IN THE MATTER OF Newfoundland and Labrador Hydro's Reliability and Supply Adequacy Study.

Requests for Information
by the Labrador Interconnected Group

LAB-NLH-001 to LAB-NLH-028

July 6, 2020

Figure 1: Modelled Scenarios

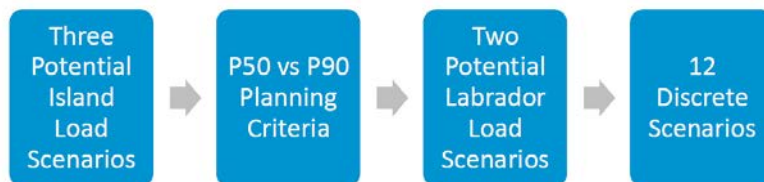
- a) Please explain why the five load scenarios initially studied for Labrador in the 2018 RRAS were first reduced to 3 scenarios in that study, and were then to 2 scenarios in the 2019 Update.

- b) Please confirm that the LIS scenarios included in the 2019 Update include only the base case (including existing data centre requirements and Tacora) and one sensitivity case (DND additional load).

- c) Please confirm that no scenarios were reviewed in the 2019 Update which include any additional cryptocurrency (data centre) loads.
- d) Please confirm (or correct) LIG's understanding that Hydro has received some 300 MW of service requests for new cryptocurrency mining customers, which are on hold pending resolution of the current proceeding regarding a Network Addition Policy.

Figure 2: Muskrat Falls and Bay d’Espoir Generation Profile

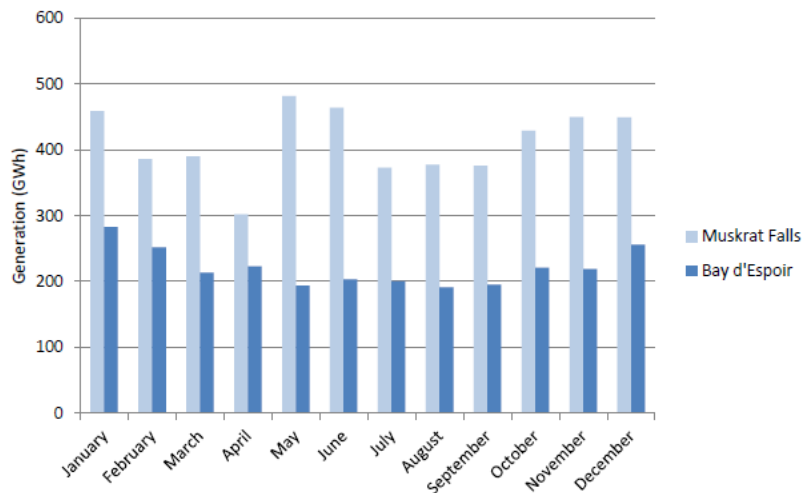
- Please confirm that a capacity shortfall in either Labrador or on the Island could, if unremedied, result in unserved load in either sub-region?
- Please confirm that, according to Figure 2, generation from MFGS in January is expected to be around 460 GWh, and indicate the corresponding average January capacity factor.

- Please explain how the last response is consistent with the value of 790 MW given as the « Gross Continuous Unit Rating » of the MFGS in Table 1 (page 13).

- Please describe in detail Hydro’s entitlements to capacity from the MFGS under the existing PPA.
- Does the existence of the Water Management Agreement affect the extent to which the Muskrat Falls project can contribute to meeting the capacity needs of the NLIS in winter? If so, please explain in detail, and provide a chart similar to Figure 2 which illustrates the MFGS contribution to Hydro’s capacity needs, taking into account the WMA.
